Consultant Advice Notice

Thornbury House – 716 High Street, Thornbury VIC 3071

Addendum to Acoustic Town Planning Report

PLAN LEVEL GROUND

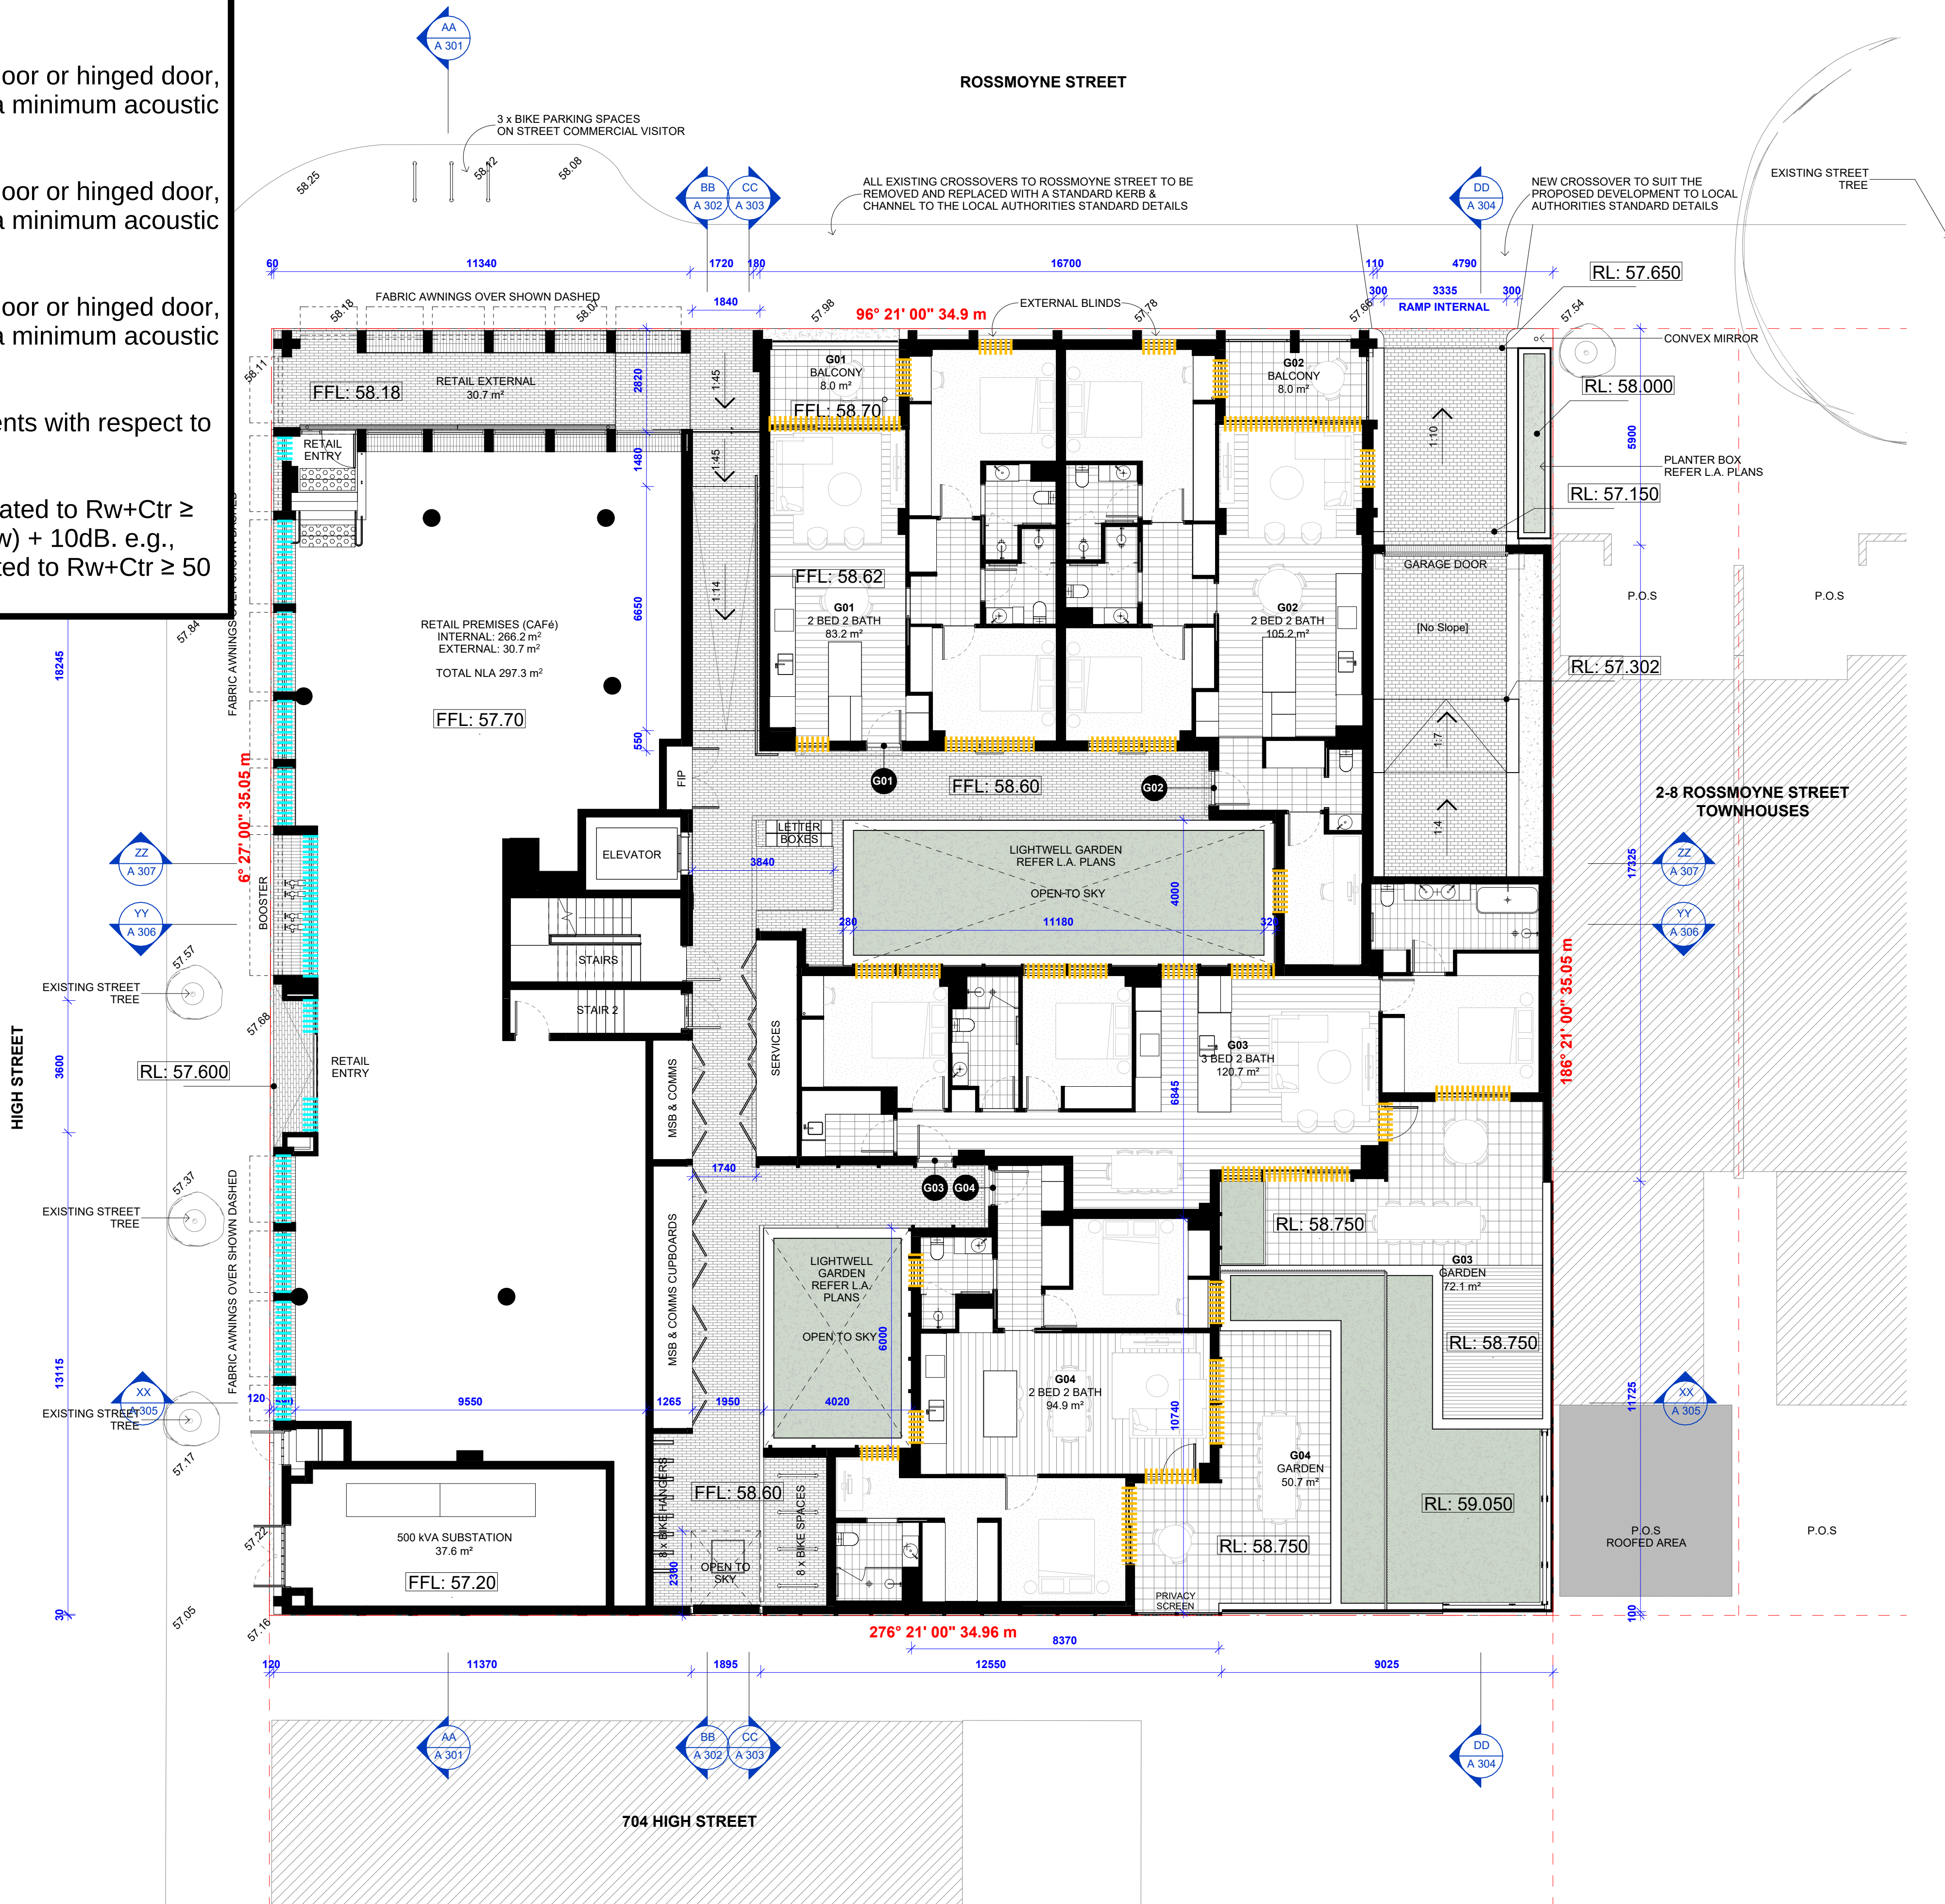
Fixed/awning glazing, sliding door or hinged door, including any frames and seals to have a minimum acoustic rating of Rw 40.

Fixed/awning glazing, sliding door or hinged door, including any frames and seals to have a minimum acoustic rating of Rw 38.

Fixed/awning glazing, sliding door or hinged door, including any frames and seals to have a minimum acoustic rating of Rw 36.

Fixed/awning glazing, sliding door or hinged door, including any frames and seals to have a minimum acoustic rating of Rw 32.

Opaque sections of the façade shall be rated to $Rw+Ctr \geq$ the glazing performance requirement (Rw) + 10dB. e.g., opaque section of the facade shall be rated to $Rw+Ctr \geq 50$ proximate to Rw 40 rated glazing.

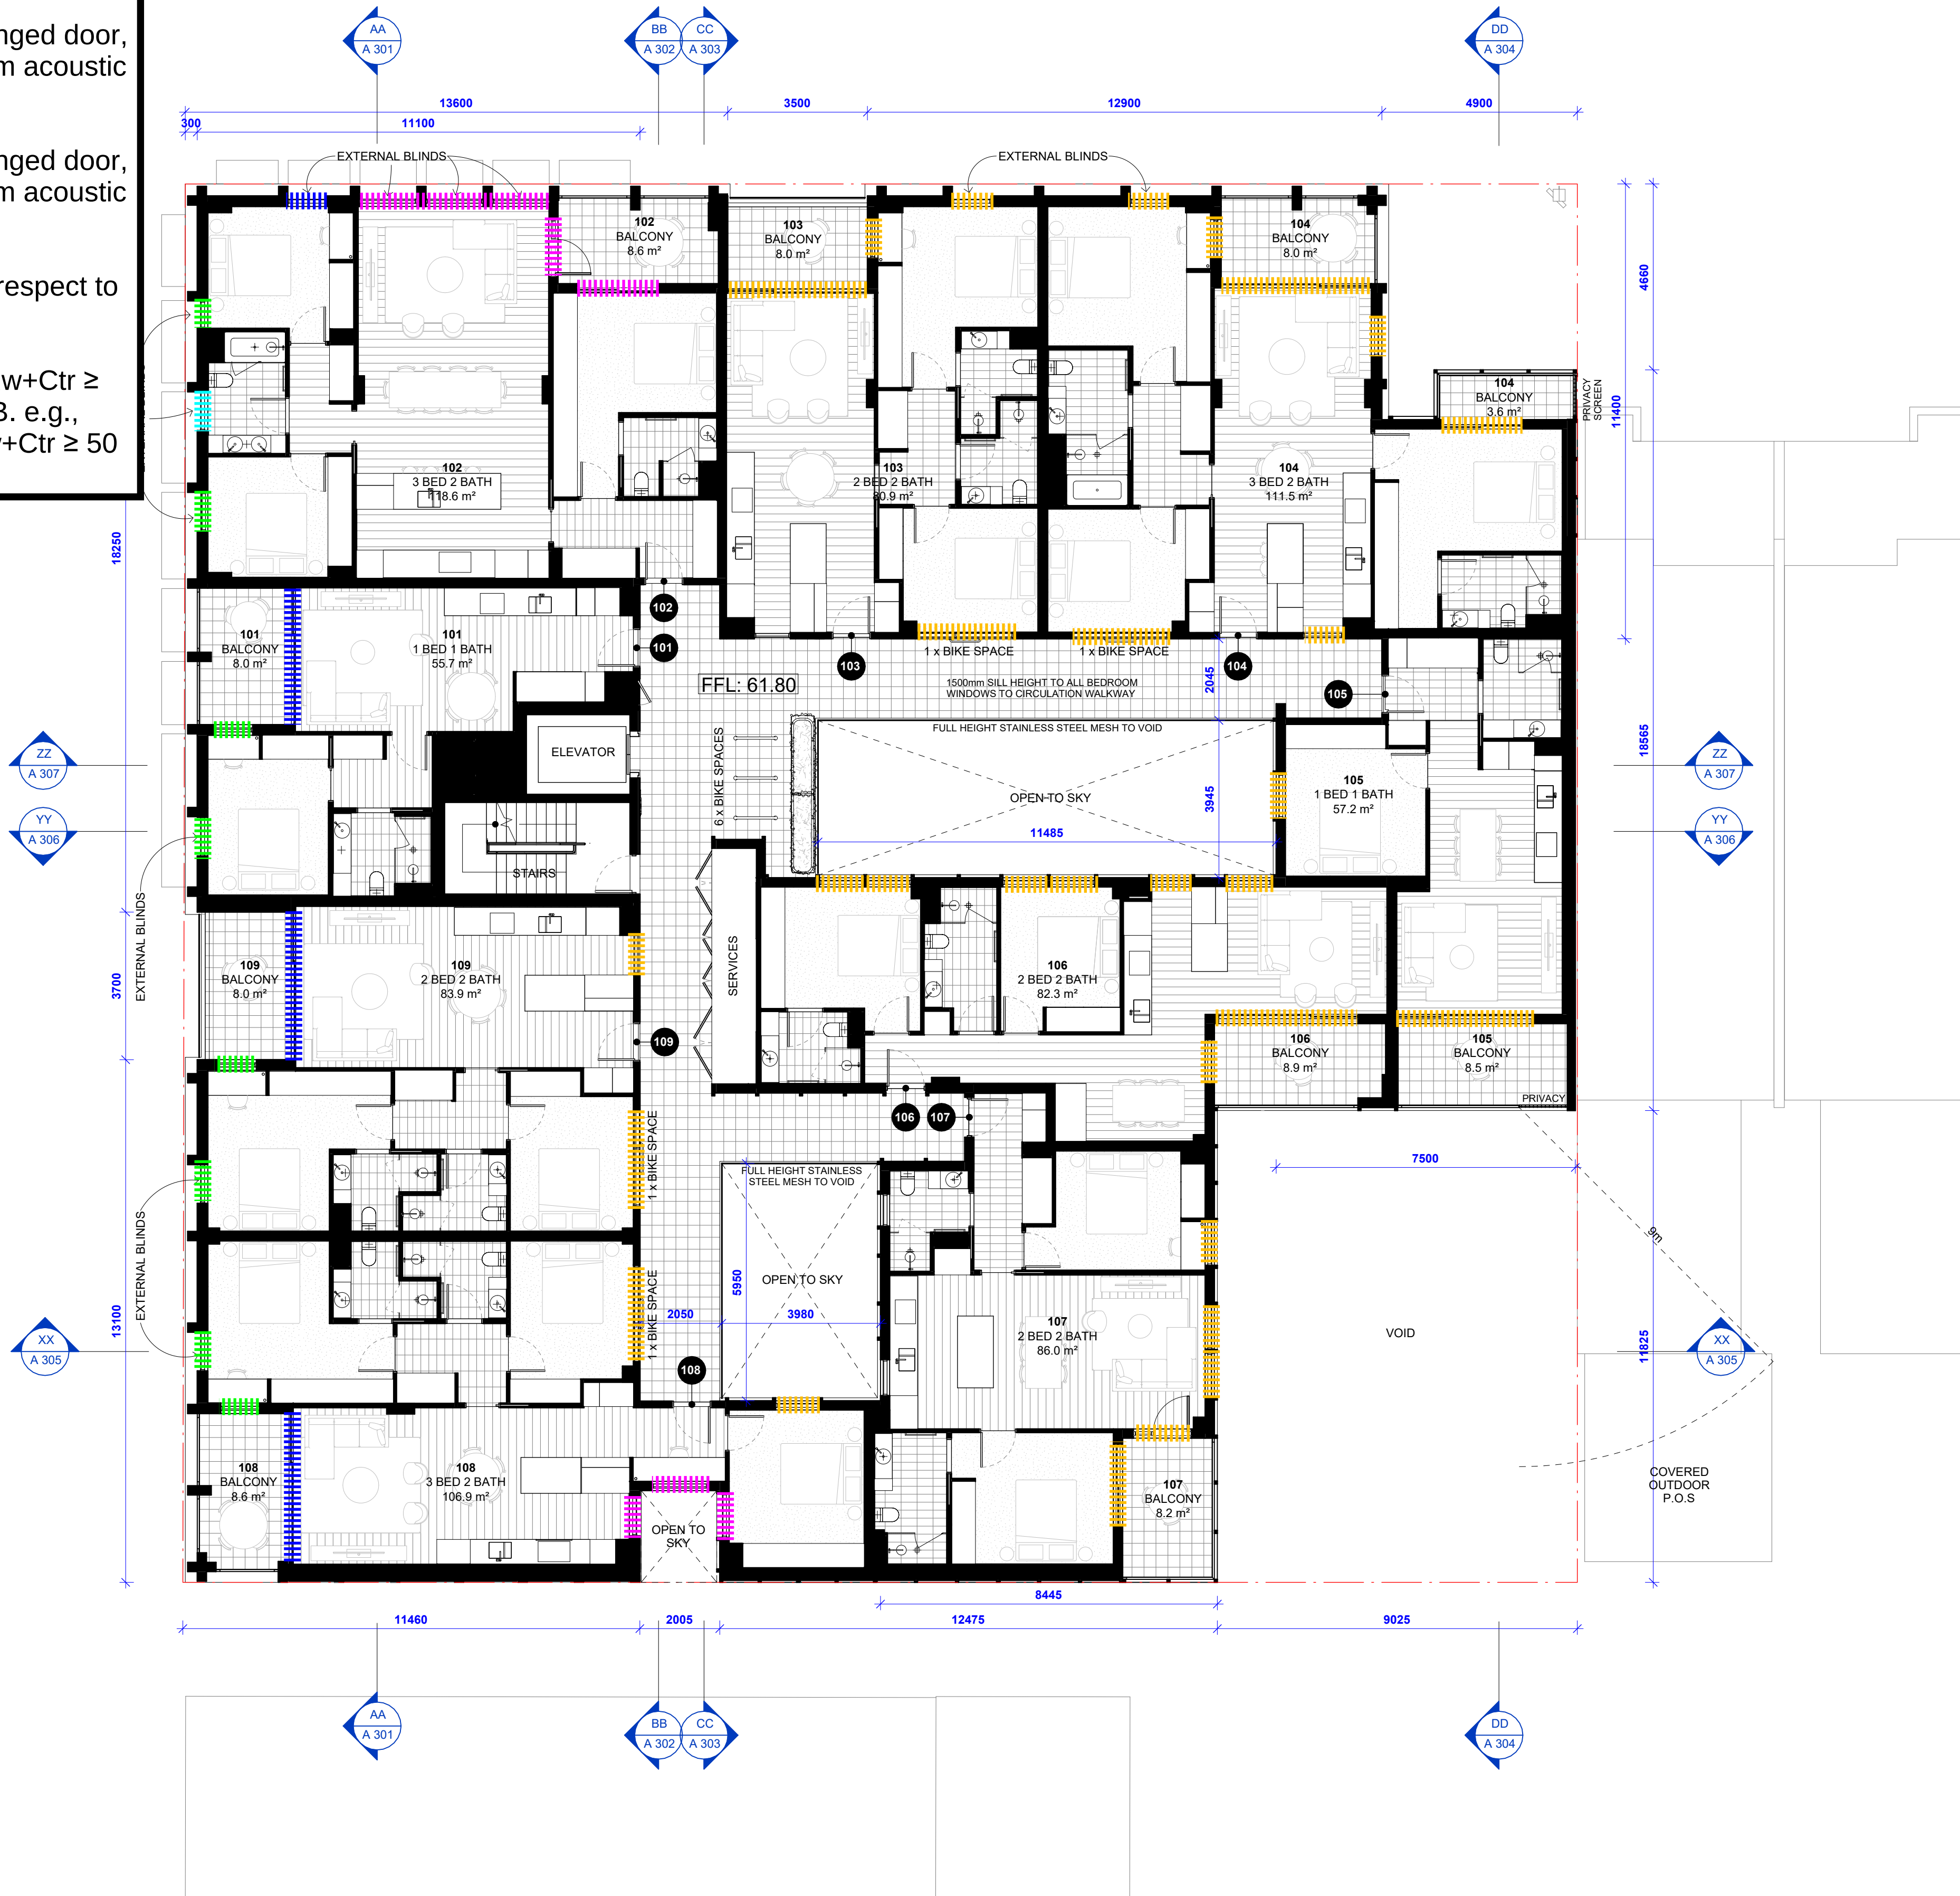
Fixed/awning glazing, sliding door or hinged door, including any frames and seals to have a minimum acoustic rating of Rw 40.

Fixed/awning glazing, sliding door or hinged door, including any frames and seals to have a minimum acoustic rating of Rw 38.

Fixed/awning glazing, sliding door or hinged door, including any frames and seals to have a minimum acoustic rating of Rw 36.

Fixed/awning glazing, sliding door or hinged door, including any frames and seals to have a minimum acoustic rating of Rw 32.

Opaque sections of the façade shall be rated to $Rw+Ctr \geq$ the glazing performance requirement (Rw) + 10dB. e.g., opaque section of the facade shall be rated to $Rw+Ctr \geq 50$ proximate to Rw 40 rated glazing.
